SPORTSMAN CLUB DETERMINATION OF USE, STATUS, AND NECESSARY LAND
USE APPROVALS/PERMITS

RE: Building Permit BLD2L400C-MIS Information Required for Processing

**BAINBRIDGE ISLAND SPORTSMAN CLUB
RIFLE RANGE IMPROVEMENTS**

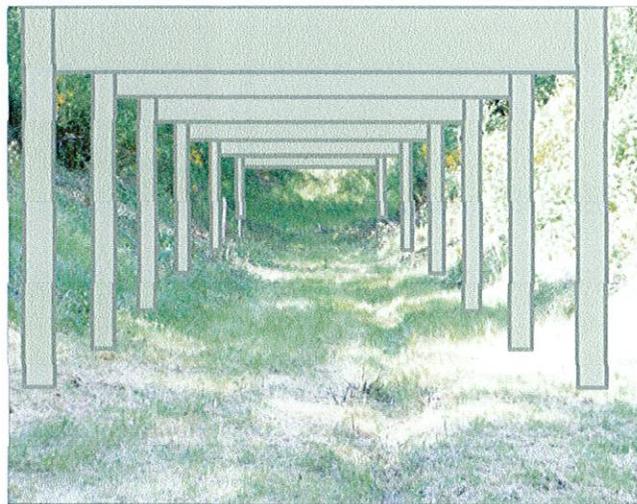
- a. Backstop / Bullet Impact Berm: The proposed Backstop / Bullet Impact Berm identified on the construction plans {Sheet C-1 and Site Plan} indicates a total height of 10 feet for the backstop / bullet impact berm. The 2012 National Rifle Association Range Source Book, Section 3.04.5.1 c includes a minimum recommended height of 20 feet for a backstop. Without the benefit of a downrange area with high terrain features or significant distance to the property line, a recommendation for the design to be modified to meet the 2012 National Rifle Association Range Source Book design criteria (document has been attached for your use and consideration).

Response: Our existing backstop berm has been surveyed at **24 feet tall**. Hence we are fully compliant with the NRA Source book recommendation.

Perhaps the confusion lies with the top of the berm cap which is 15 feet tall. It is specifically designed somewhat lower than the top of the berm to better protect the sand berm and bullets contained therein from moisture. This reduces the chance of lead leaching into the soil between mining activities to remove lead deposited.

Nonetheless the height of the berm cap and for that matter the actual berm height is somewhat irrelevant in that the no blue sky beams only permit a view for shooters that is approximately 7 feet high. Herewith is an artist's conception of the view downrange from the shooters position. Please note the tunnel affect that is presented to the shooter. The bullet cannot go up and out and the side berms restrict the bullet from leaving the range either left or right.

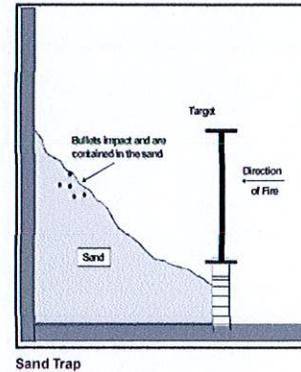
- b. Overhead Baffles: The proposed overhead baffle cap design indicates a proposed use of plywood and 2" x 4" dimensional lumber with gravel filled voids.

Response: Our berm cap is designed with a 2" x 4" gravel filled plywood box. However the baffling reference of the Source Book, Section 3.04.6.1.1 specifically applies to baffling designed to stop a full frontal impact of a projectile. Our berm cap is not designed for that purpose.

The design of the berm cap was in support of our EPA compliant sand trap was at least in part taken from the EPA's Best Management Practices for Lead at Outdoor Shooting Ranges.

The primary purpose of our berm cap is to keep the "ballistically acceptable" sand (EPA recommended) at least partially isolated from rainfall. We added the rock filled aspect of the berm cap again out of an abundance of caution to capture unlikely ricochets emitting from our "ballistically acceptable" sand trap. The NRA Source Book is silent on Berm Caps.
